Subject: Engineering Technical Review – Permit to Construct
Blue Ridge Paper Products Inc, Landfill Number 6D-South
Haywood County, Permit #44-06, Document ID No. 7071

Subject: Engineering Technical Review – Permit to Construct
Blue Ridge Paper Products, Inc. – Landfill No. 6D-South
Haywood County, Permit #44-06, Document ID No. 7071
Response to March 27, 2009 Review Comments

As requested, Sevee & Maher Engineers, Inc. (SME) has prepared a set of responses to the review comments provided by Mr. Allen Gaither of NCDENR on the Landfill No. 6D-South design. The comments were in Mr. Gaither's letter dated March 27, 2009 Engineering Technical Review. For ease of review, we have provided the comment along with our response.

**FIGURE 1
ANNUAL PHASES OF OPERATION
BLUE RIDGE PAPER PRODUCTS
INC. -
CANTON MILL
CANTON, NORTH CAROLINA
LANDFILL NO. 6 AMENDMENT**

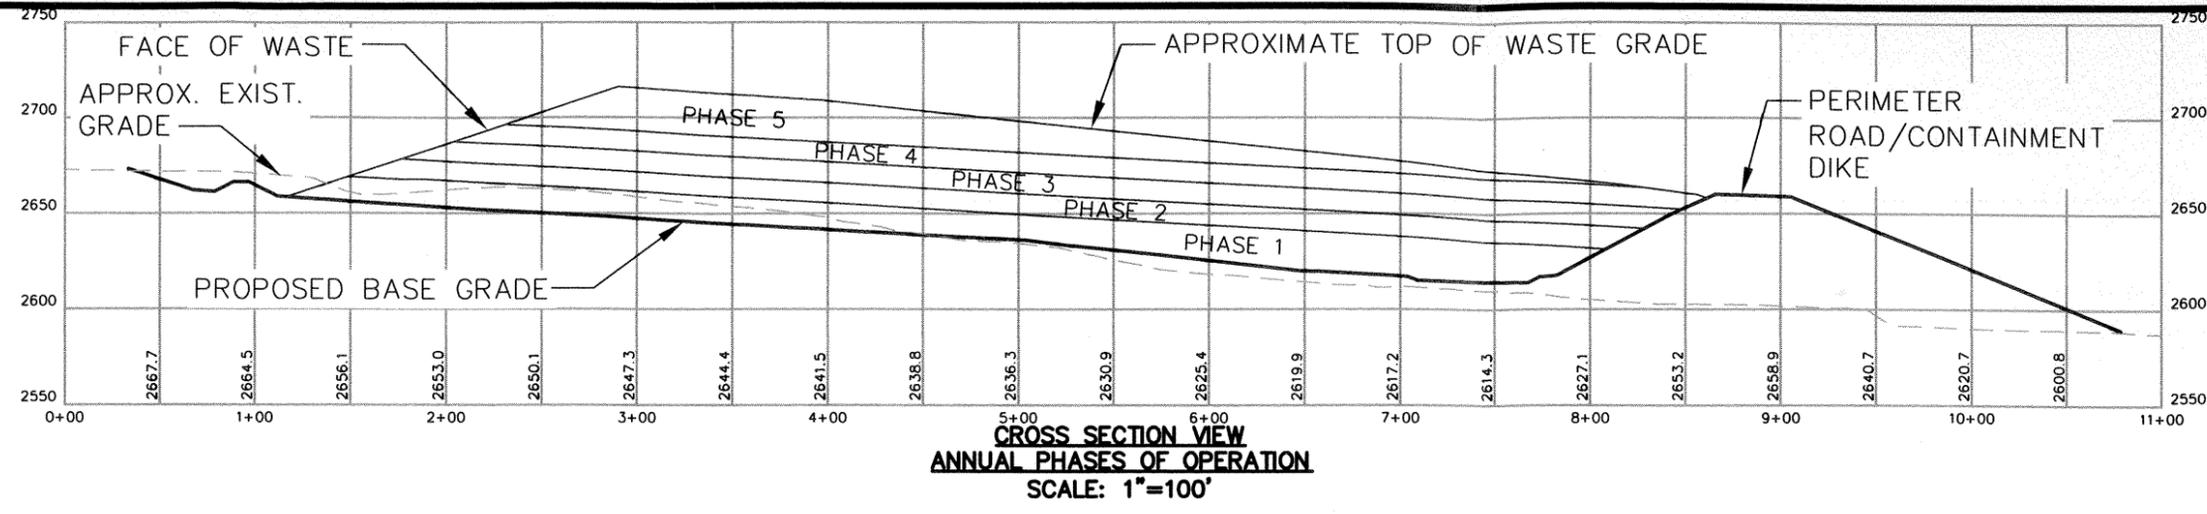
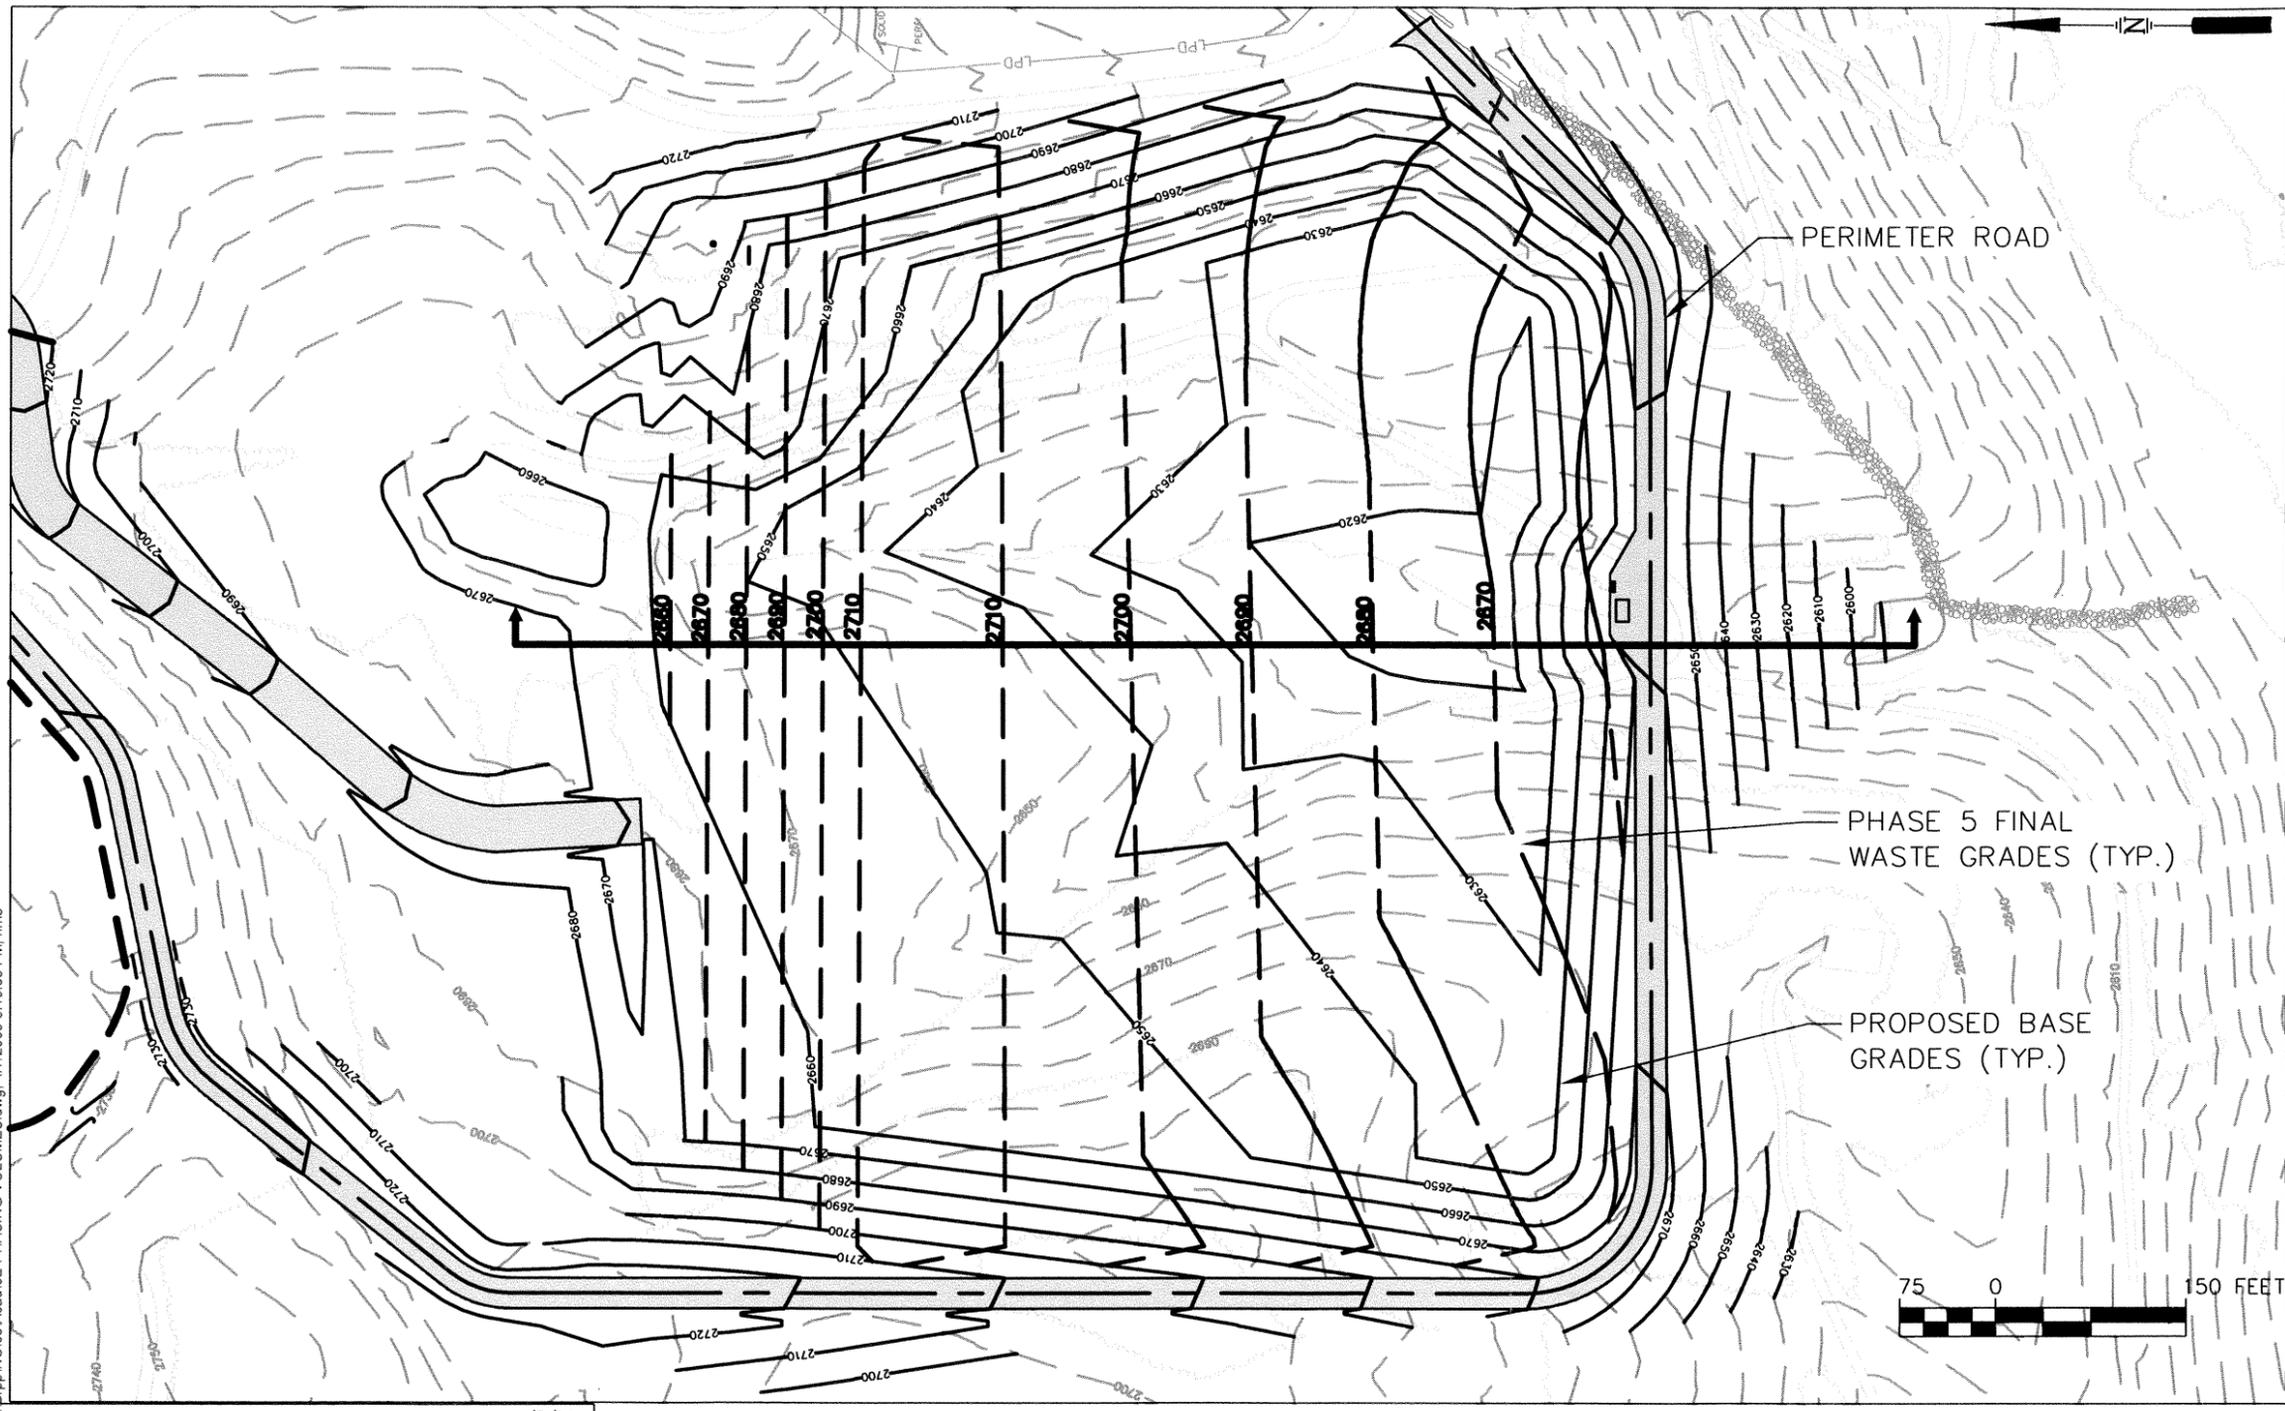
2. **Page 2-16 states an operations manual, not included in this design, ... will include site development showing phases or progression of operation. Rule .0504(2)(g) requires, for reviewing a construction plan application, a site development showing phases or progression of operation. Please provide a drawing showing at a minimum, annual phases of operation.**

SME's Response. A cross section for area 6D-South is shown on Figure 1 attached with these comments. The landfill will be sequenced in uniform lifts over the entire area. The section shows the approximate thickness for each of the five phases. Each phase is sized to meet the annual waste capacity of approximately 200,000 cubic yards. Landfilling of the 6D-South area is expected to take 5 years.

FIGURE 1
ANNUAL PHASES OF OPERATION
BLUE RIDGE PAPER PRODUCTS
INC.
CANTON MILL
CANTON, NORTH CAROLINA
LANDFILL NO. 6 AMENDMENT

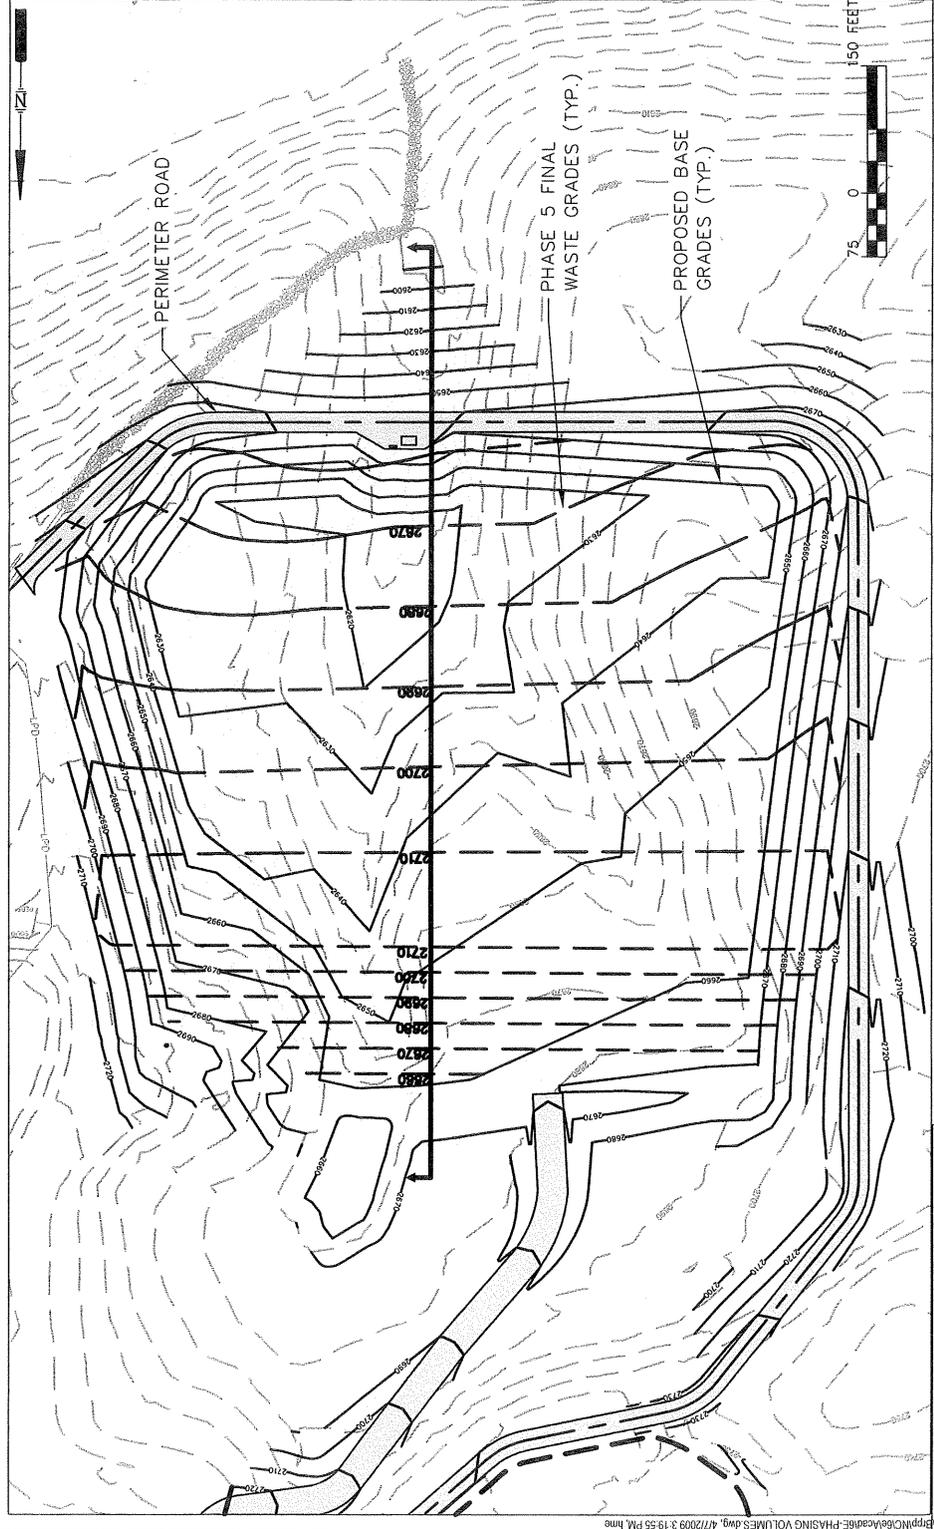
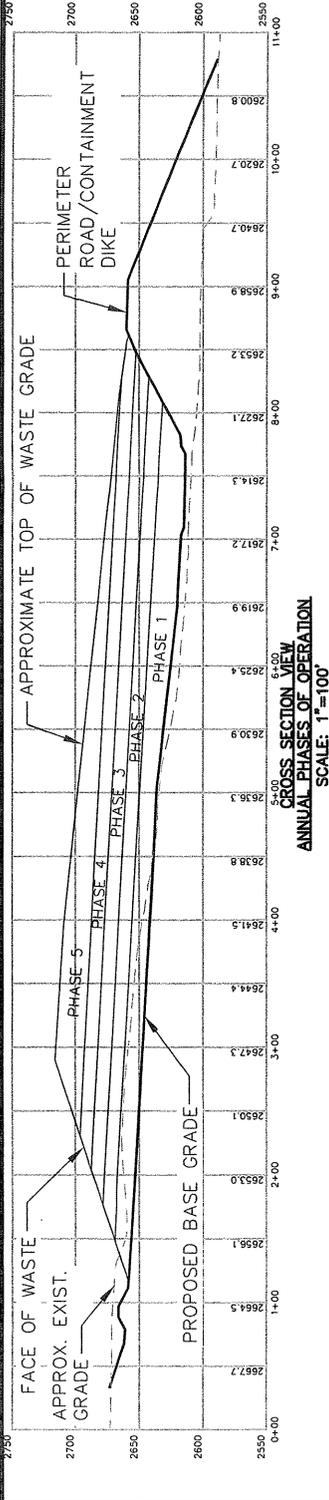
3. **Page 2-17 states an operations manual, not included in this design, ... will include site development showing phases or progression of operation. Rule .0504(2)(h)(v) requires, for reviewing a construction plan application, a description of systematic usage of area, operation, orderly development and completion of the sanitary landfill. Please provide this description for review of the construction plan.**

SME's Response. The operations for 6D-South will continue the same practices as those currently used in 6A-West. A summary of the operating methods is described below.

The sludge, woodwaste and lime mud will be dumped by the haul truck operator and spread by an equipment operator. The landfill operator will place the waste in lifts 10 to 15 feet thick. As waste is dumped from the top of the lift the landfill operator will push and spread the waste over the working face. The waste will be spread in layers no greater than 2 feet thick. By spreading the waste in thin layers, the waste is allowed to drain, greater compaction is achieved, and stability of the working face is maintained.

Waste placement for area 6D-South is divided into five phases. Phase 1 encompasses approximately 11 acres of the entire area 6D-South base, has a depth of approximately 13 feet and a capacity of approximately 210,000 cubic yards. Phase 2 will be placed directly on top of Phase 1, has a depth of 11.5 feet a capacity of approximately 203,300 cubic yards. Phase 3 will be placed directly on top of Phase 2, has a depth of 11 feet and a capacity of approximately 213,100 cubic yards. Phase 4 will be placed directly on top of Phase 3, has a depth of 10.5 feet and a capacity of approximately 201,400 cubic yards. Phase 5 will be placed

directly on top of Phase 4 and filled to a depth which meets final grades and has a capacity of approximately 215,000 cubic yards.

FIGURE 2

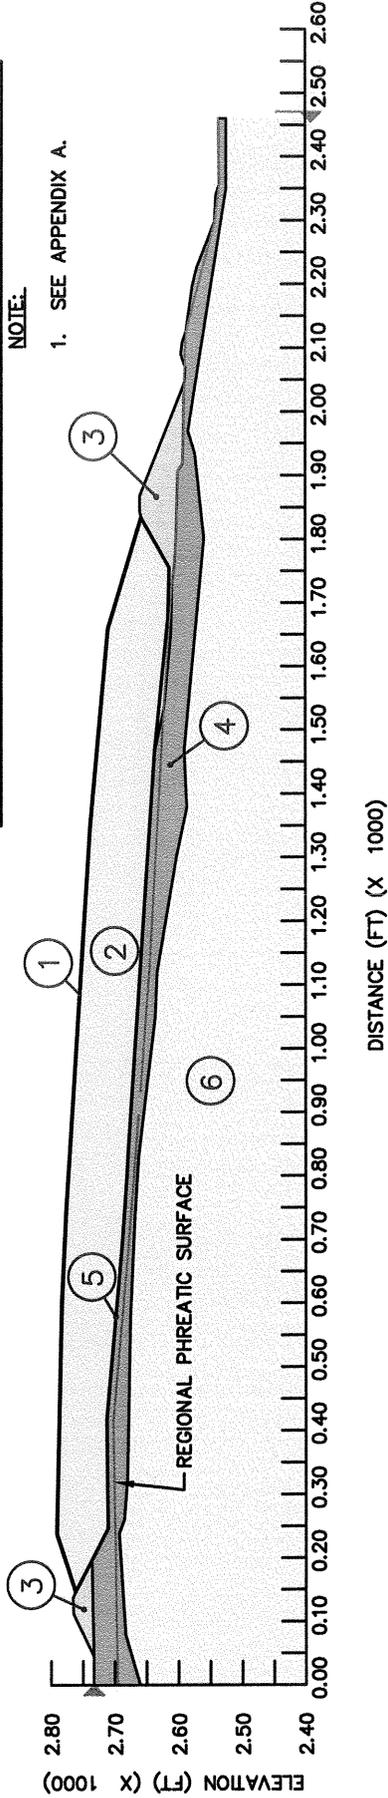
8. **The Liner (balloon 5) and the Regional Phreatic Surface pointers appear to be swapped on Figure 2 in Appendix B.**

SME's Response. The pointers were inadvertently swapped as stated. The figure has been updated and attached with these responses.
